# STAFF RECOMMENDATION

NCPC File No. 7096

## FORT BELVOIR – NORTH POST POST EXCHANGE (PX) SHOPPING CENTER

June 24, 2010

*Proposed PX Shopping Center Floorplan*

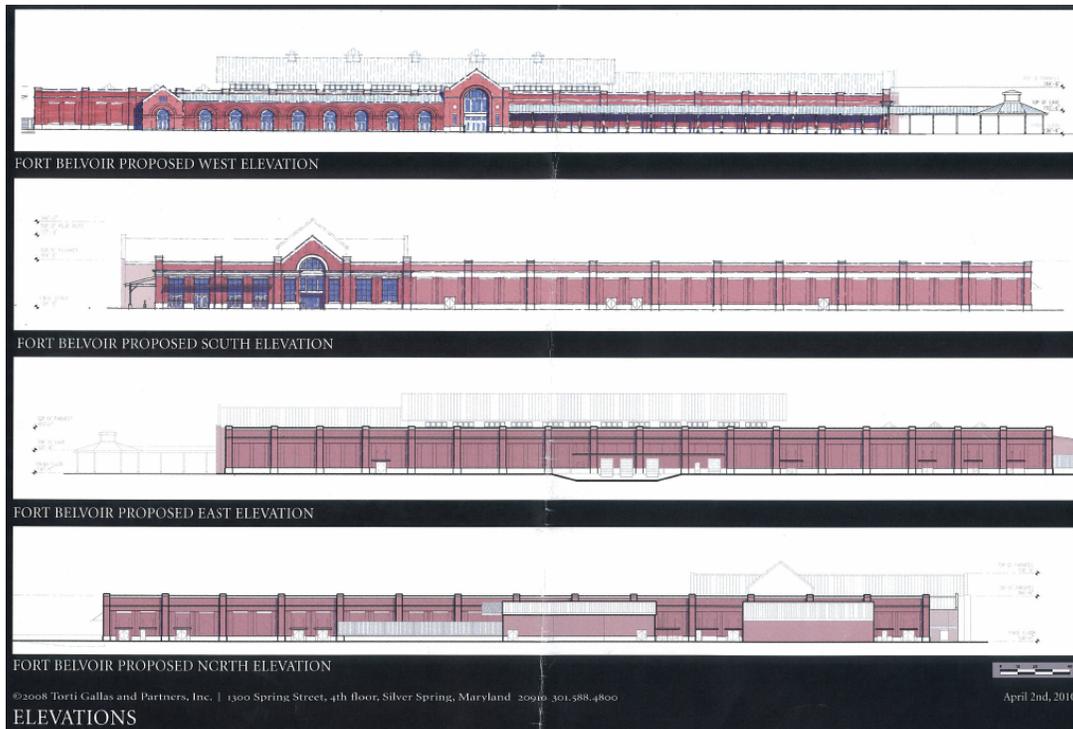
- 7) Is the traffic circulation pattern in both surface parking lots one-way or two-way?
- 8) Cupola extension of a covered walkway, as mentioned in the narrative, is not clearly identified on the plan.

*Future North Post Town Center Phase 3 Diagram*

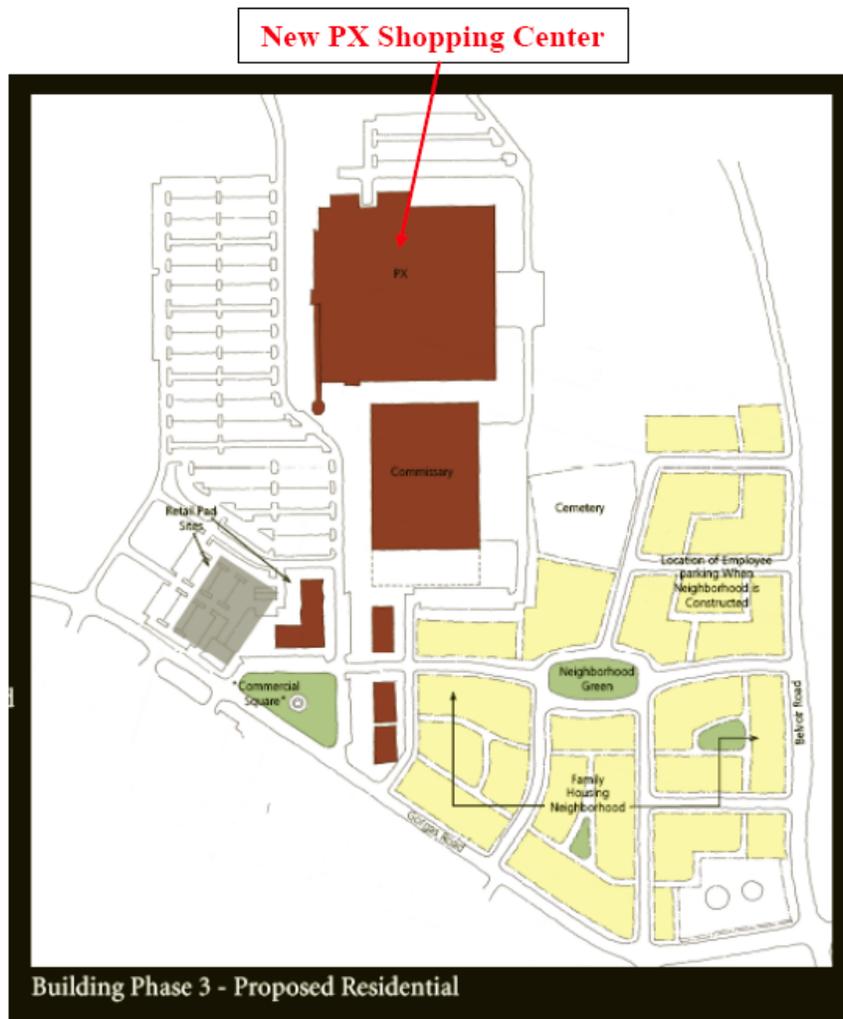
The basic form of the proposed shopping center, with its single-level and large surface parking lot, is suburban in nature, and appears to be inconsistent with the intent of the planned future mixed-use North Post Town Center. The shopping center will be located in close proximity to other future retail and higher density residential uses, constructed as part of the future town center development. However, the concept of the project, with a single-level and located adjacent to a large expanse of surface parking, is inconsistent with a true “town center” form.

- **Recommends** that the new PX shopping center be constructed as a multi-level building rather than a single-level building as proposed, or as a single-level building with a “green” roof to minimize the amount of new impervious surface on-site;
- **Recommends** that all new construction related to the project be limited to areas that minimize tree loss to the maximum extent possible;
- **Recommends** that the Army closely coordinate with the Commonwealth of Virginia and Fairfax County as the design of this project and all future projects are developed and finalized.
